Inspection Report

Station: Any Station Unit: 0 Report Name: 1-Superheater Secondary Inlet

AREA: Superheater Secondary Inlet

Repair #: 2-a Record:# 20
Action: TUBE RESTORATION WELD-P1
Priority #: 1
Inspector: Smith J.

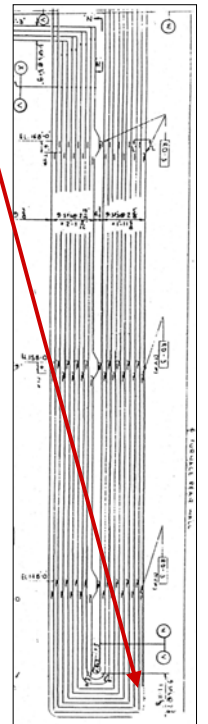
Restore tubing to MWT by applying 18" x 2" pad welds on the leading edge side of the following assembly/tube(UT result):

- A26/2F(0.434)**
- A32/2F(0.435)**
- A32/3F(0.420)**

The area to be pad welded will begin at the centerline of the lower loop bend and extend upward for a length of 18".

Repair #: 3-a Record:# 15
Action: GRIND FOR INSPECTION-P1
Priority #: 1
Inspector: Smith J.

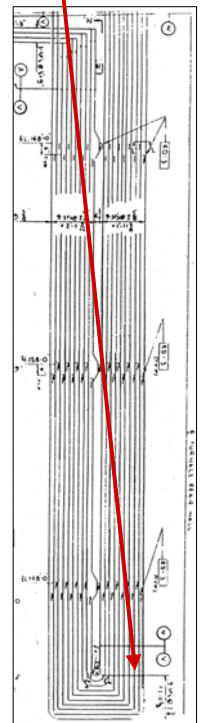
Grind a 6" x 2" (L x W) area on the leading edge of tube 3F at assembly 7 to a 'white' metal finish and call for re-inspection. As visually identified, a substantial amount of wall loss is evident. Given the current surface texture, UT could not be performed.

Repair #: 4-a Record:# 48
Action: TUBE RESTORATION WELD-P2
Priority #: 2
Inspector: Smith J.

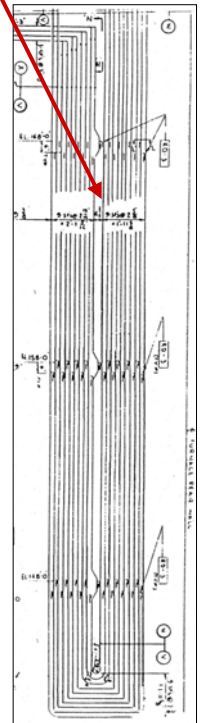
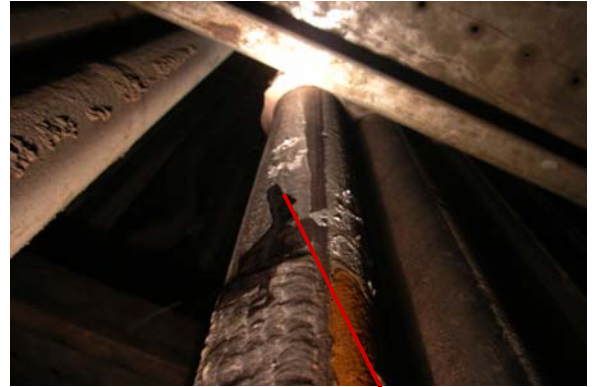
Restore tube 10F of assembly 18 by applying a 16" pad weld due to a remaining wall thickness of 0.395" (78% of MWT). The pad weld will be applied above an existing pad weld and extend to the split ring casting for the aforementioned length.

Repair #: 5-a Record:# 5
Action: FLEX TIE REPLACEMENT-P2
Priority #: 2
Inspector: Smith J.

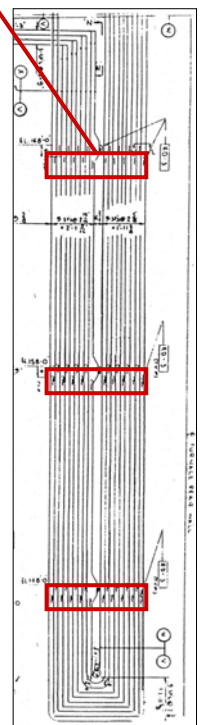
Multiple flex ties throughout assemblies 1 through 56 at elevations 148'0", 158'0", and 168'0" were identified as deficient with the following scenarios:

- (1) Completely failed
- (2) Cracked at the attachment weld
- (3) At the origin of failure, wall loss is present from weld fracture
- (4) Flex tie remnants at failure origin is abrading adjacent tubing
- (5) Tubing is out-of-plane 1 to 2 tube diameter from the centerline of the assemblies

It is recommended that all flex ties be replaced as documented in the spreadsheet at the close of this report. Note the following:

- (1) Install ties using the same rod as the parent material of the tube
- (2) Avoid installing the new tie in the previous location of the existing tie
- (3) Attach new tie a minimum of 3 inches from the previous location to avoid overlap of heat affected zones

As an alternative to flex tie replacement, consider installing split ring castings encompassing tubes 1F through 10F and 10R through 1R of all 56 assemblies at three elevations 149'0", 159'0", and 169'0".

Repair #: 6-a Record:# 22
Action: ALIGN AND ATTACH-P2
Priority #: 2
Inspector: Smith J.

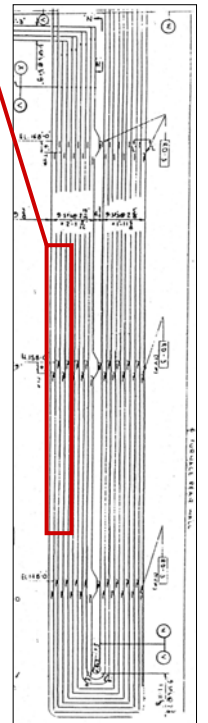
Located at **assembly 47**, tubes 3F through 3R are out-of-plane from the centerline of the assembly approximately 1 tube diameter at the lower loop section (Elevation 143'0"). At elevation 153'0", tube 3R is bowed out-of-plane an estimated 1 to 1 1/2 tube diameters spanning for a length of 15'+. **It is recommended that the alignment of all tubing be restored; tube replacement may be required to restore the alignment of tube 3R.**

Consider using a 'vise' to re-position tubing and install split ring castings encompassing tubes 1F-10F and 10R-1R at elevations 149', 159' and 169'.

Repair #: 6-b Record:# 33
Action: ALIGN AND ATTACH-P2
Priority #: 2
Inspector: Smith J.

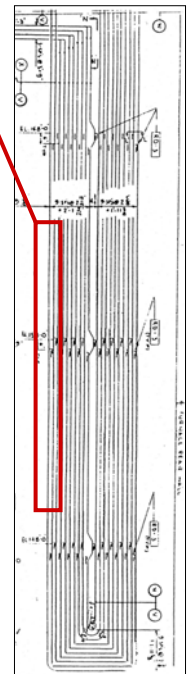
At elevation 153'0", tubes 1R and 2R of assembly 37 are bowed out-of-plane an estimated 2 tube diameters spanning for a length of 20'+. It is recommended that the alignment of all tubing be restored; tube replacement may be required to restore the alignment of tubes 1R and 2R.

At time of flex tie or split ring casting installation, replacement may be necessary to align tube properly with assembly.

Repair #: 7-a Record:# 12
Action: MONITOR CLOSELY-P2
Priority #: 2
Inspector: Smith J.

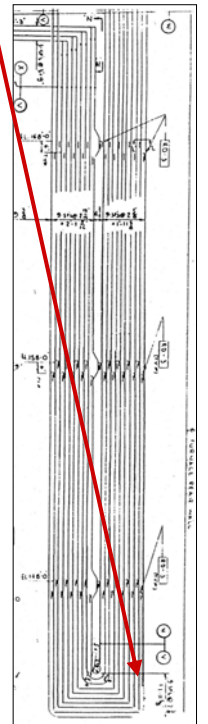
During future overhauls, monitor the following SSH inlet tubes for further wall loss:

- A9/2F(0.516)
- A16/2F(0.504)
- A23/1F(0.539)
- A24/1F(0.530)
- A25/1F(0.529)
- A25/3F(0.490)
- A26/1F(0.537)
- A32/4F(0.528)

Currently, the tubing is within 76% to 85% of MWT as UT verified. Although this threshold is shield criteria, shielding is not recommended. Given the temperatures at this location, the shields are likely to degrade at a much higher rate from thermal fatigue.

Repair #: 14-a Record:# 17
Action: REMOVE SAMPLE FOR ANALYSIS-P3
Priority #: 3
Inspector: Smith J.

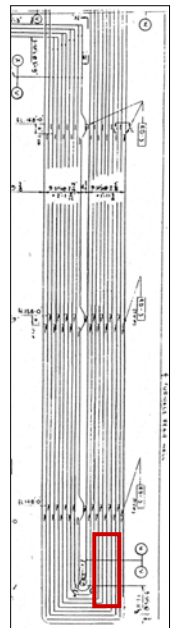
Visual indications of LTOH (long-term overheating) and/or coal ash corrosion were identified on the leading edge of the SSH inlet component. The indications were most prevalent on tubes 2F through 4F at elevation 143'0" on assemblies 5 through 38. It is recommended that three (3) tube samples be removed for a metallurgical analysis condition assessment to verify the indications.

Repair #: 9-a Record:# 38
Action: PLAN FOR FUTURE REPLACEMENT-P3
Priority #: 3
Inspector: Smith J.

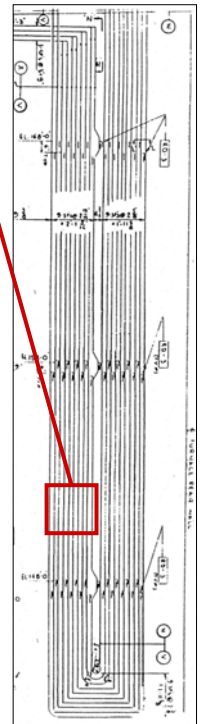
Plan for future replacement of the following tubes within IK-13/14 path:

A47/1R(3' replacement): From the centerline of the blower, cut lines will extend up 18" and down 18"

A54/10R(4'6" replacement): From the centerline of the blower, cut lines will extend up 2'6" and down 2'

Both tubes have been previously pad weld repaired and the pad welds have washed out wherein tubes are approaching base material.

Repair #: 9-b Record:# 44
Action: PLAN FOR FUTURE REPLACEMENT-P3
Priority #: 3
Inspector: Smith J.

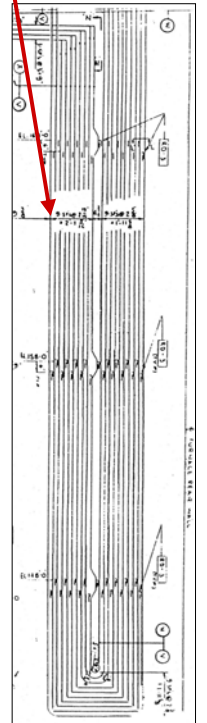
Plan for future replacement of the following tubes within IK-15/16 path:

A20/1R(3'6" replacement): From the centerline of the blower, cut lines will extend up 24" and down 18".

Note: The pad weld on the tube has degraded and tube is approaching base material.

Repair #: 13-a Record:# 37
Action: MONITOR CLOSELY-P3
Priority #: 3
Inspector: Smith J.

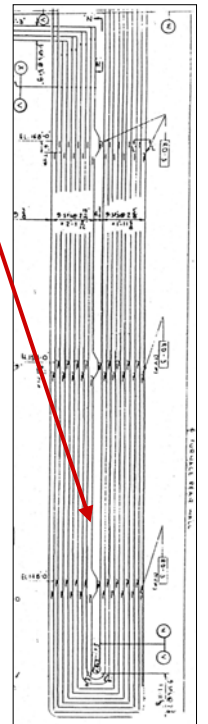
Monitor the trailing side of the following tubes within IK-13/14 blower path:

- A6/5R(0.610)
- A6/10R(0.575)
- A50/10R(0.569)

No repairs are required at this time; tubing is above 85% of MWT.

Repair #: 13-b Record:# 46
Action: MONITOR CLOSELY-P3
Priority #: 3
Inspector: Smith J.

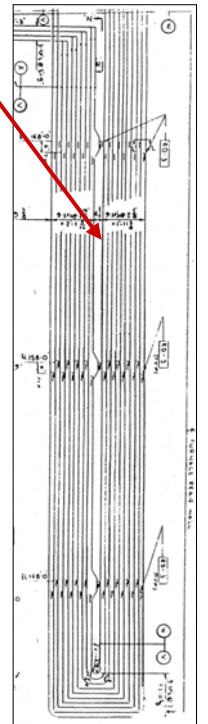
During future overhauls, monitor tube 10F of assemblies 1 through 56 for further wall loss from erosion degradation.

- A18/10F(0.452 - below existing pad weld)
- A19/10F(0.440 - above existing pad weld)

Repair #: 10-a Record:# 1
Action: FLEX TIE REPLACEMENT-P3
Priority #: 3
Inspector: Smith J.

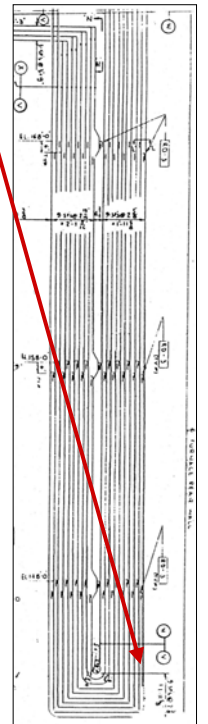
Flex ties were identified as either cracked or failed between tubes 1F through 3F on assemblies 1 through 56 at elevation 143'0". It is recommended that all flex ties at the aforementioned locations be replaced.

- (1) Install ties using the same rod as the parent material of the tube
- (2) Avoid installing the new tie in the previous location of the existing tie
- (3) Attach new tie a minimum of 3 inches from the previous location to avoid overlap of heat affected zones.

Repair #: 11-a Record:# 31
Action: SPLIT RING CASTING INSTALL-P3
Priority #: 3
Inspector: Smith J.

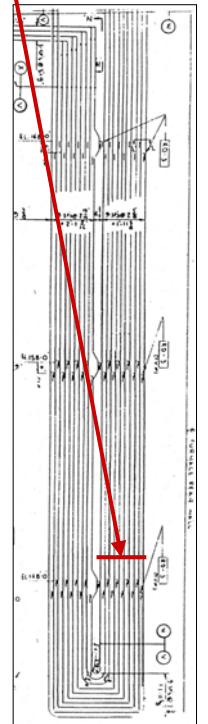
The split ring castings at elevation 150' on tubes 1F through 10F are starting to disengage at the following assemblies:

- 31
- 33
- 34
- 36

It is recommended that new castings be installed at the aforementioned locations.

Repair #: 15-a Record:# 35

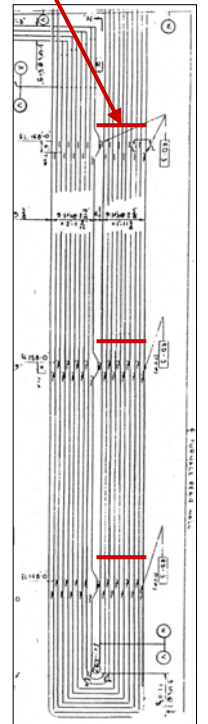
Tighten the hardware on the split ring castings which are beginning to extend off tubing at the following locations:

The installation of additional nuts and bolts may be required where missing. Once installed and tightened, apply a tack weld between the bolt and nut to secure position.

Repair #: 8-a Record:# 49

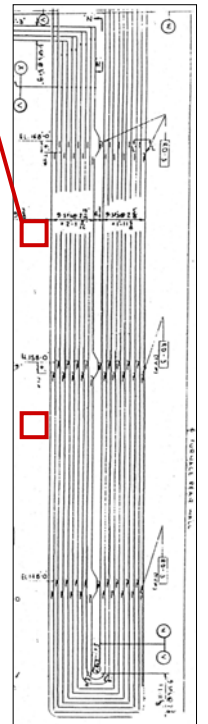
Weld repair the cracked blower sleeves at the following IK blowers:

- IK-13
- IK-14
- IK-15
- IK-16

Repair #: 12-b Record:# 53
Action: REFRACTORY INSTALLATION-P3
Priority #: 3
Inspector: Smith J.

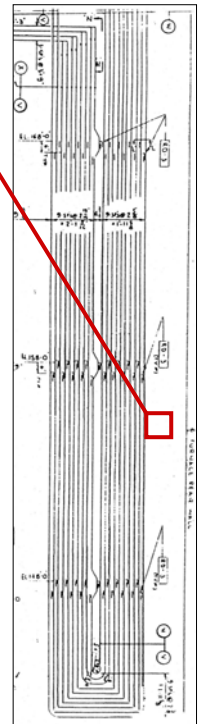
The refractory seal between the roof tubes and both left and right sidewalls has deteriorated and is no longer present at various locations. It is recommended that a new refractory seal be installed at both sidewalls spanning from the front WW to the rear WW screen tubes.
